THE GARDENS AT NORTH CAREFREE CONSTRUCTION DRAWINGS EL PASO COUNTY, STATE OF COLORADO

| GARDENS AT NORTH CAREFREE TITLE SHEET | |

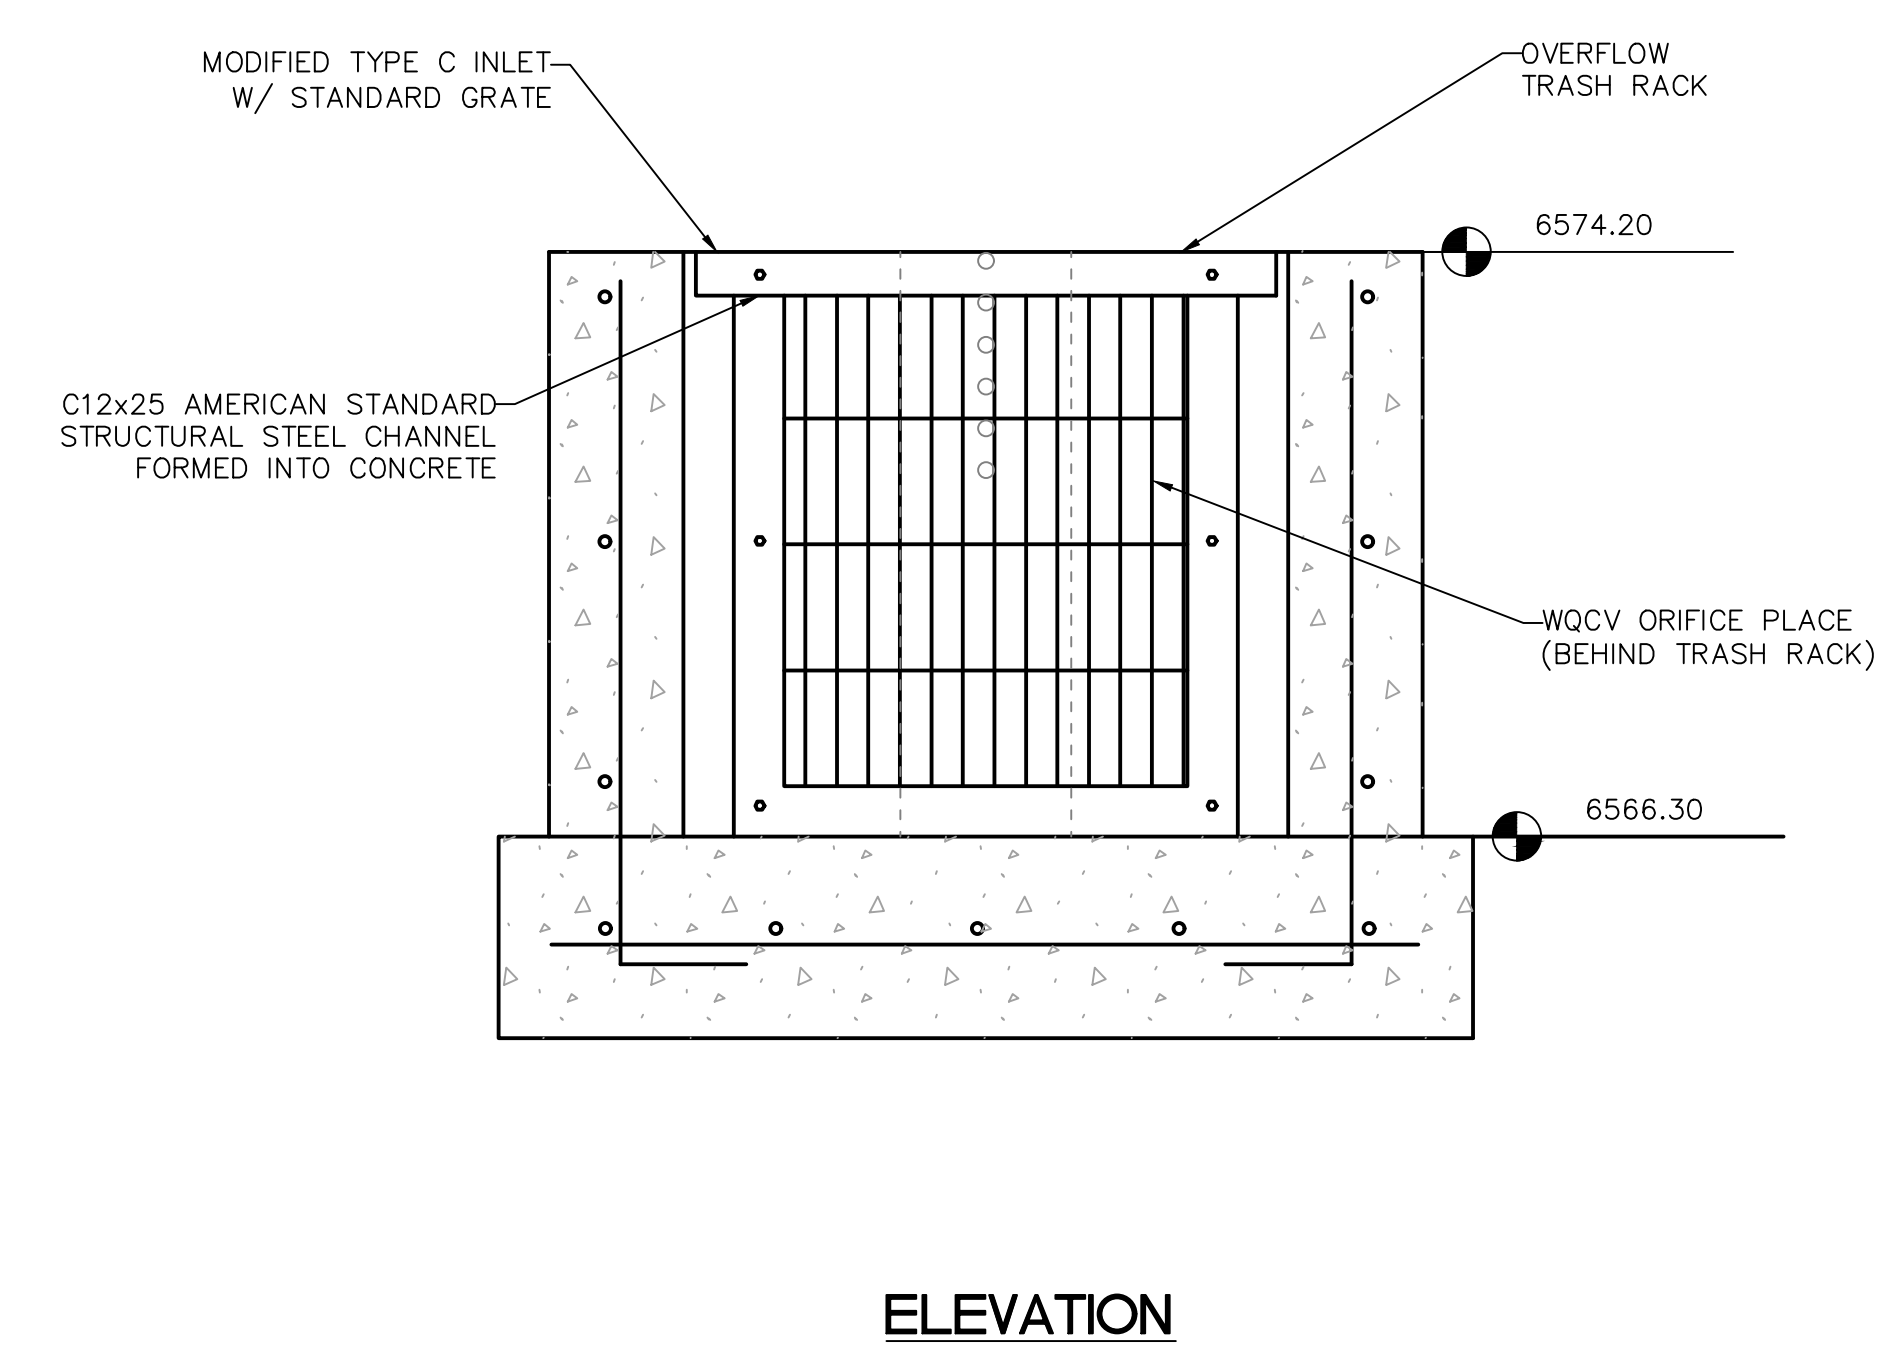
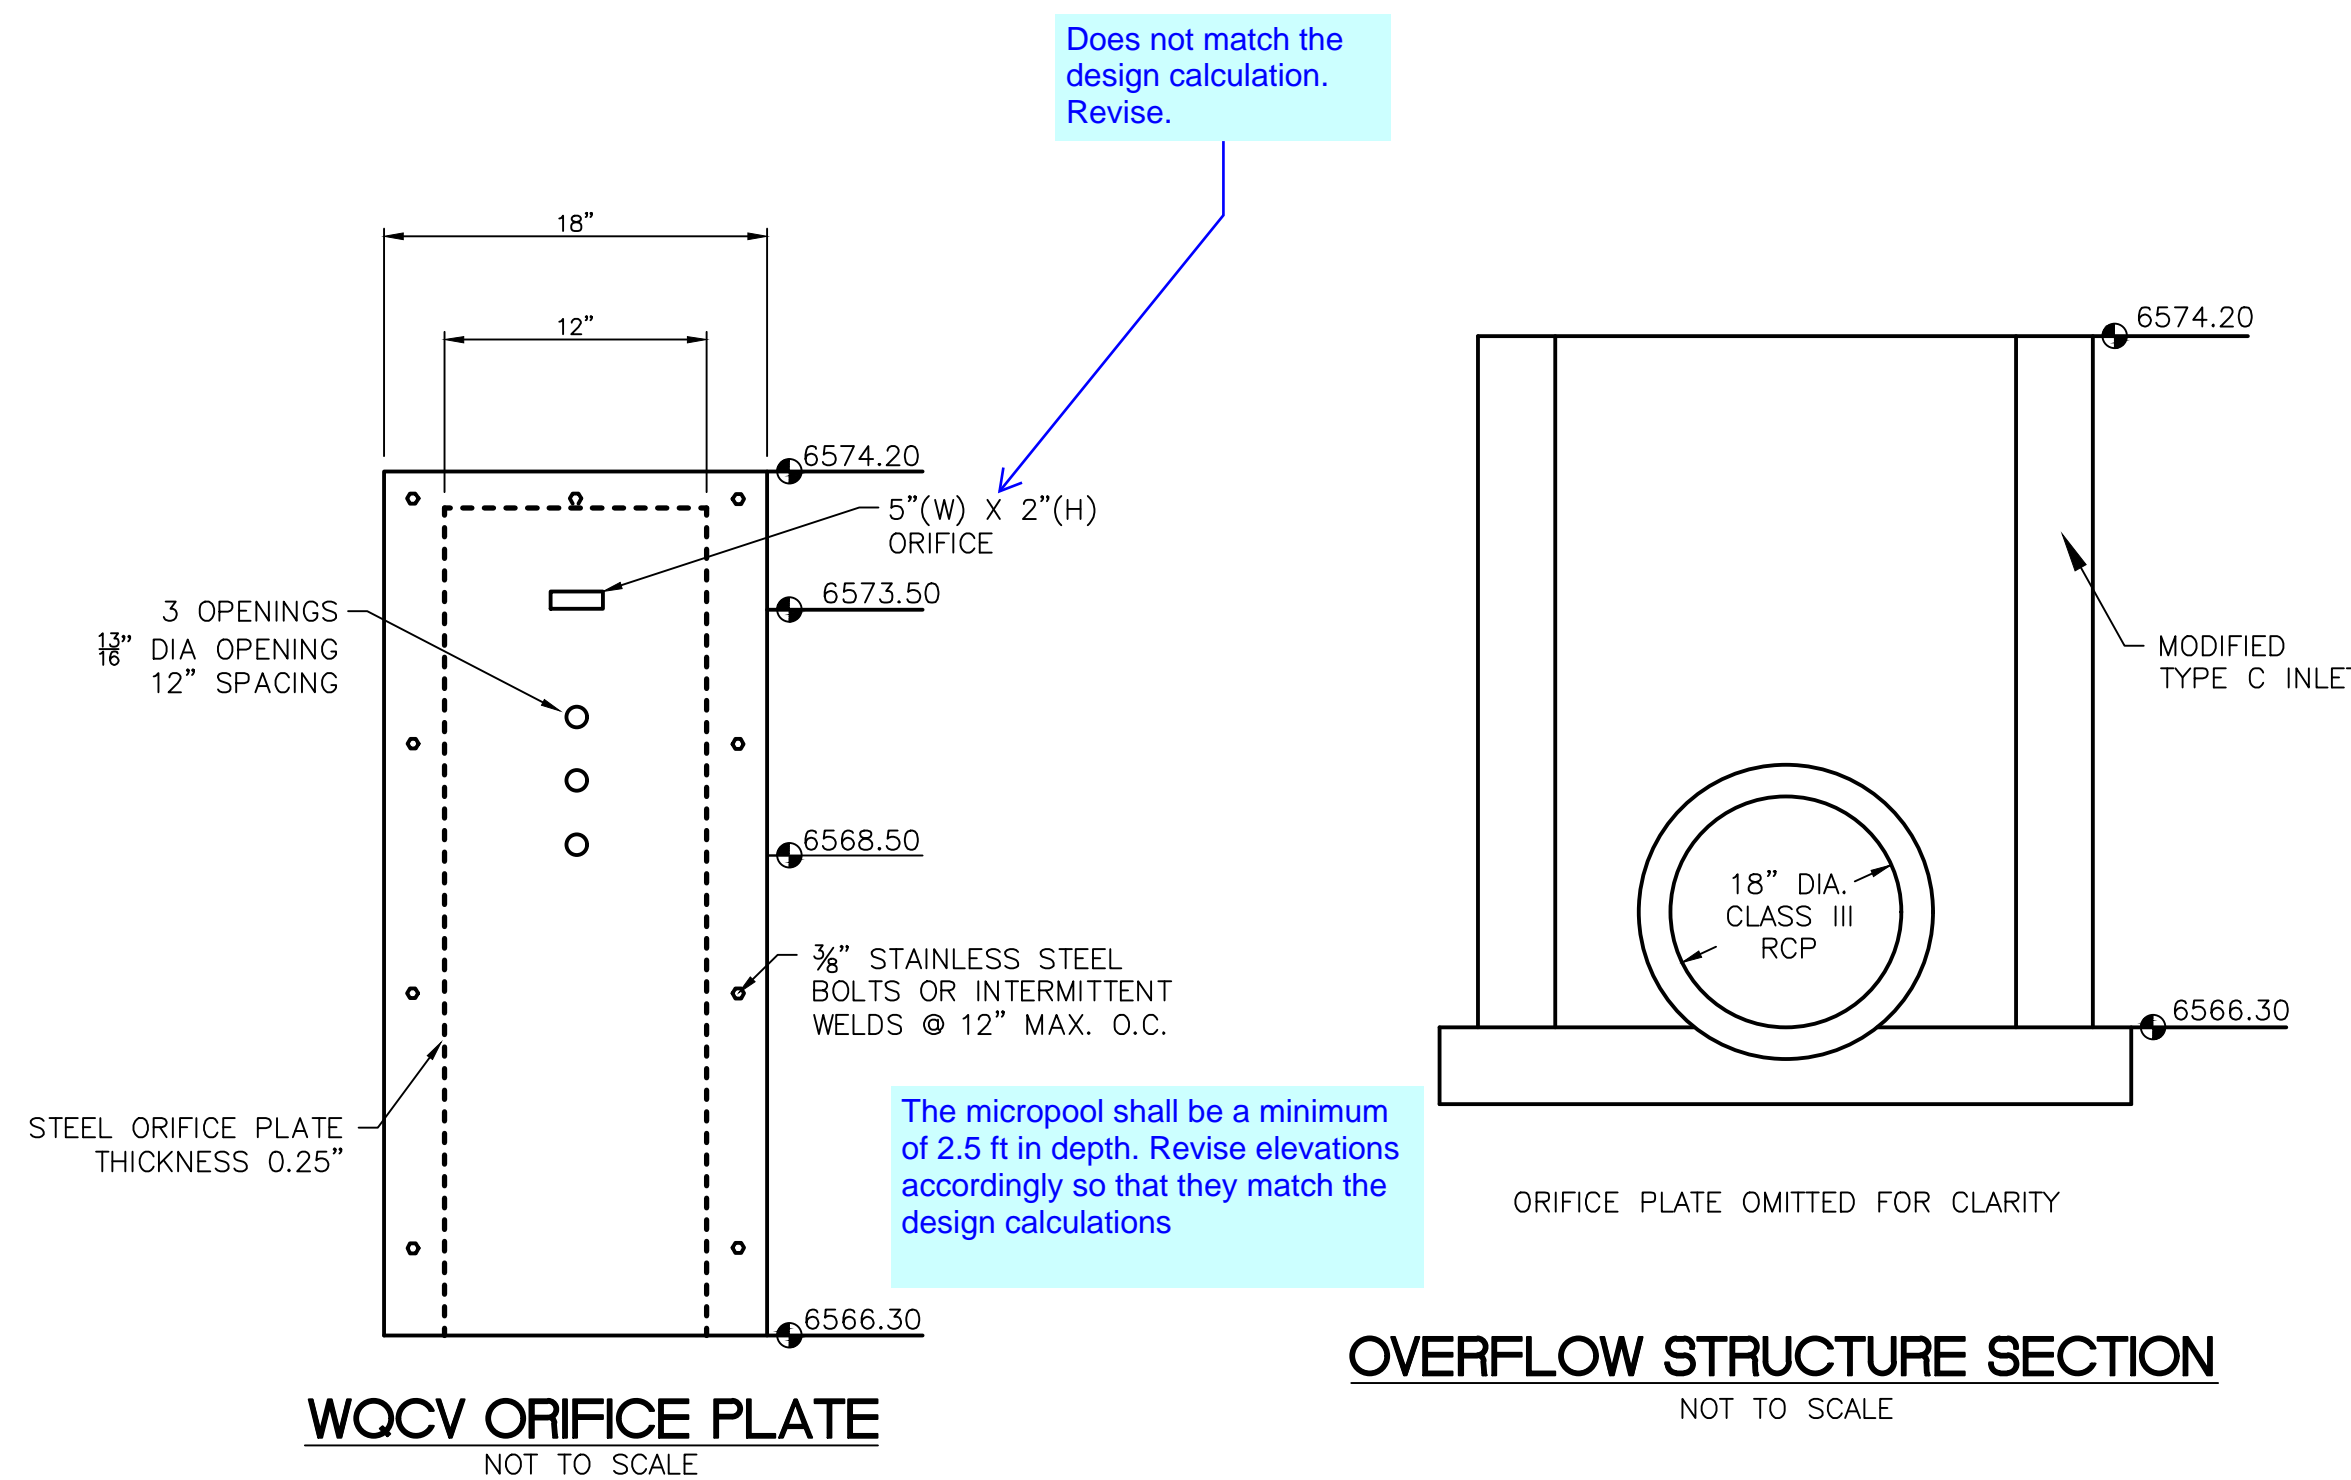
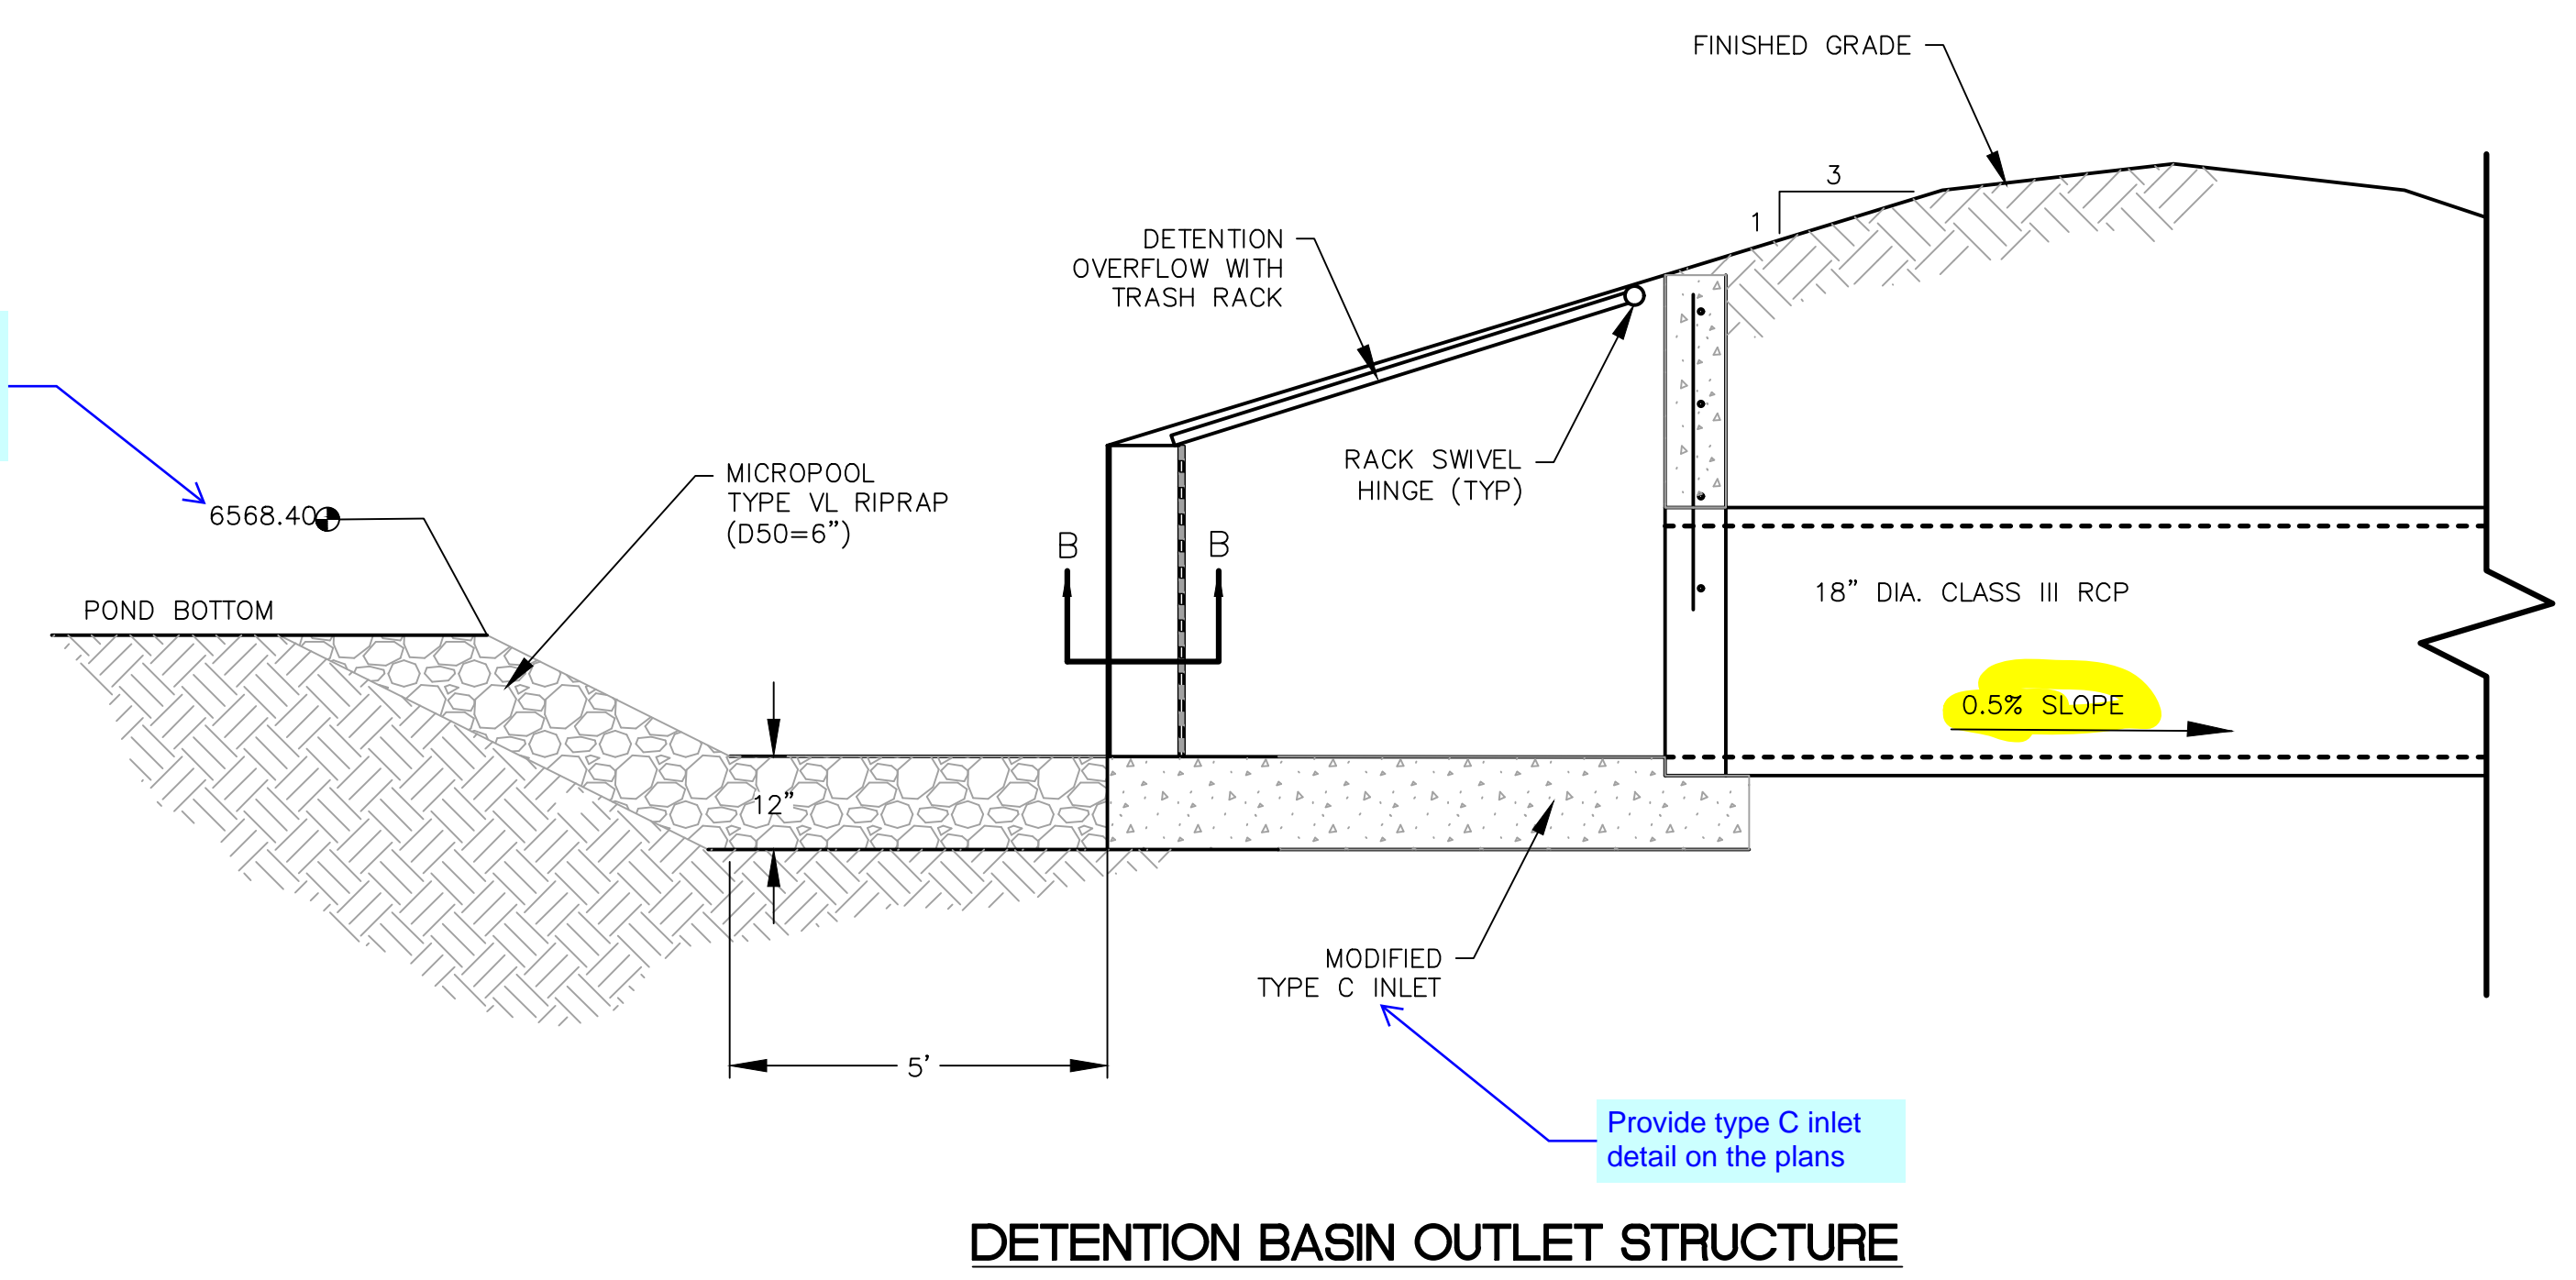
Ensure that all the elevations shown on this page and the profile are matching.

Provide type C inlet detail on the plans

Does not match the design calculation. Revise.

The micropool shall be a minimum of 2.5 ft in depth. Revise elevations accordingly so that they match the design calculations
